# **SAN DIEGO DISTRIBUTED SOLAR PHOTOVOLTAICS IMPACT STUDY**

Final Report

February 2014

Appendix B: Stakeholder Comments

**Figure 2. Electric Grid Diagram with Utility and PV NEM Customer Services Listed**

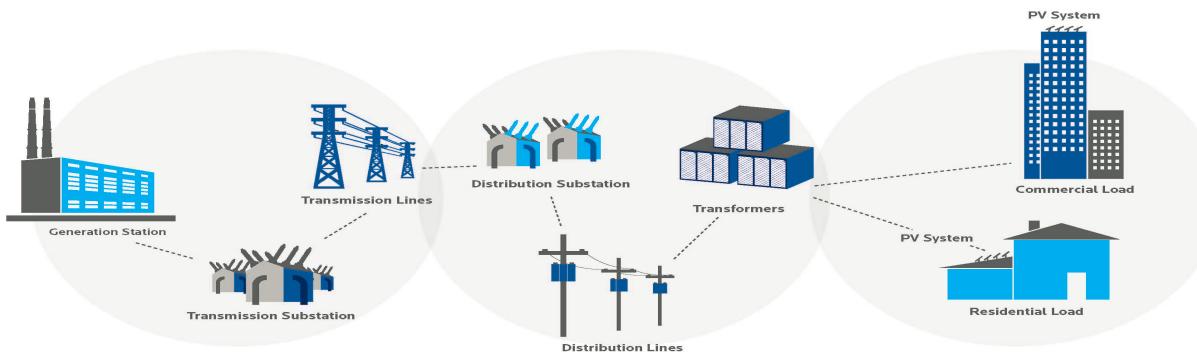
Several commenters in the review presentation and in written comments expressed concern or confusion about the charts included in the report attempting to compare the utility costs of distributed PV to distributed PV value by year in Figure 2 and in Figure 17 in Section 4.1.

*The goal of the charts was to provide a usable and meaningful comparison of disparate costs, as some of costs are expressed on a capacity basis (\$/MW) and some on an energy basis (\$/MWh). As this led to more confusion than clarity, we have removed these charts from the revised report.*
